WO 2005/092640 ————— PCT/EP2005/003024

MARKED-UP COPY OF SUBSTITUTE SPECIFICATION~~—————~~ **SANDING DEVICE FOR RAIL VEHICLES**

FIG 1

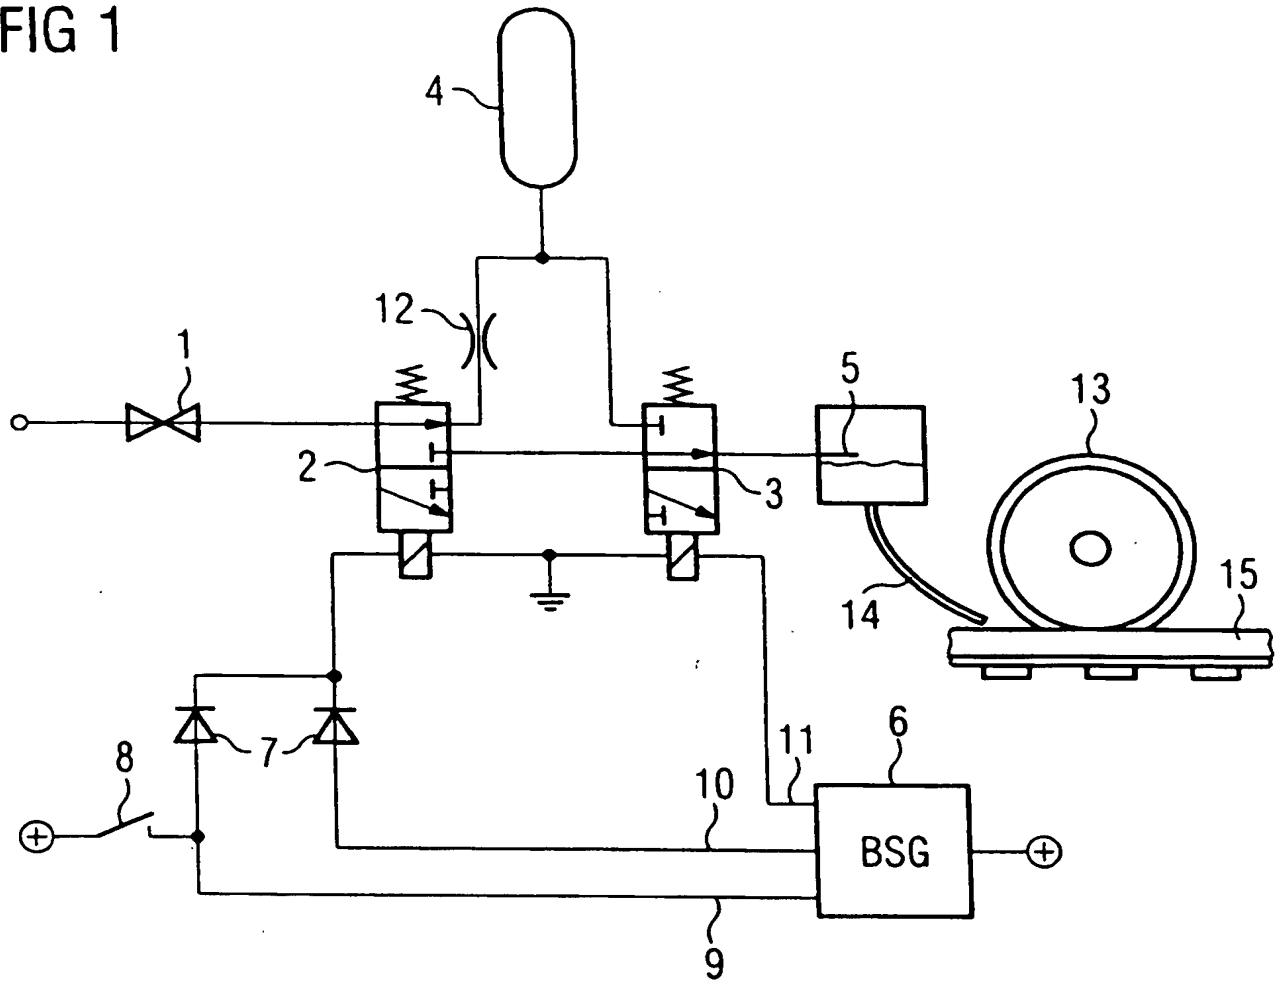
Please enter the following sheet of drawing as a Replacement sheet that includes the following changes to Fig. 1:

Delete "BSG" in element 6

Add numerical designations 16, 17 and 18.
